June 24, 1996

Idaho State University (ISU) will be making the following organizational changes with regard to the administration and operation of the AGN-201 Reactor in the Lillibridge Engineering Building on the ISU campus. The current Reactor Administrator, Dr. Alan Stephens, will officially retire from ISU on June 30. The following will be the newly assigned persons to the relevant reactor operational positions.

Administrative Organization of the Idaho  
State University AGN-201M Reactor Facility  
NRC License R-110

Figure 1

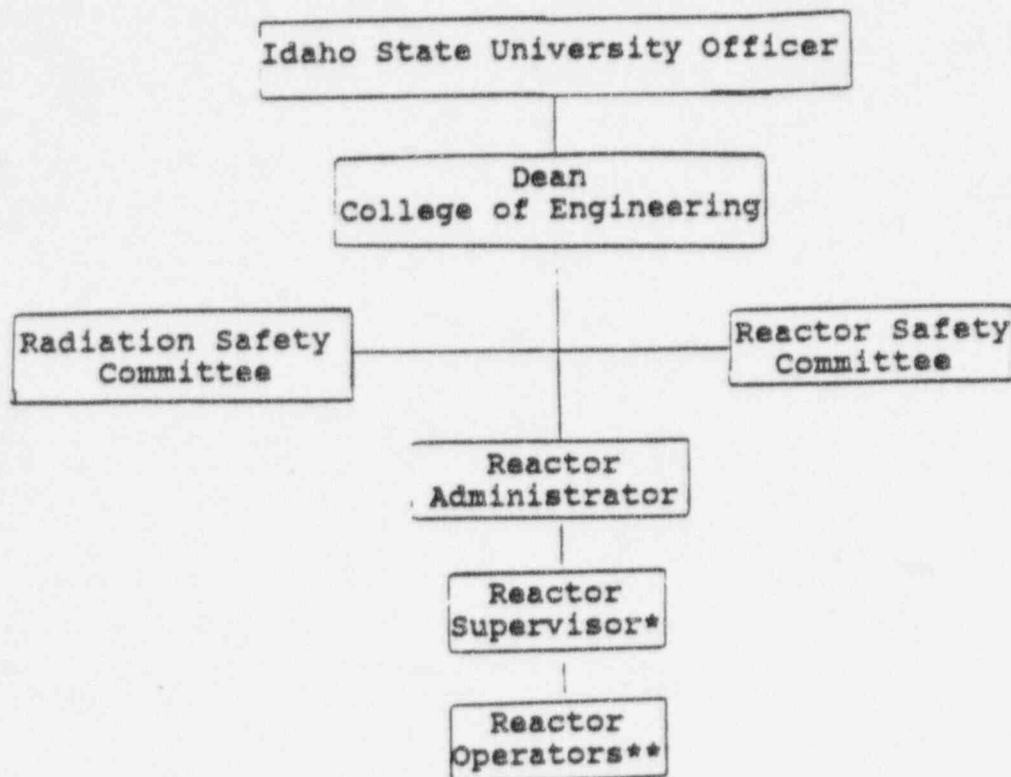
The organization chart in the current Technical Specifications needs to be altered, as shown in the attached, since it shows both a ISU Officer and the Dean of Engineering. We will be changing the words "ISU Officer" to "ISU Administrative Representative," and will eliminate the Dean of Engineering box. We expect to submit a revision to the Technical Specifications, for this and some other minor changes, to the NRC for review before September 1996.
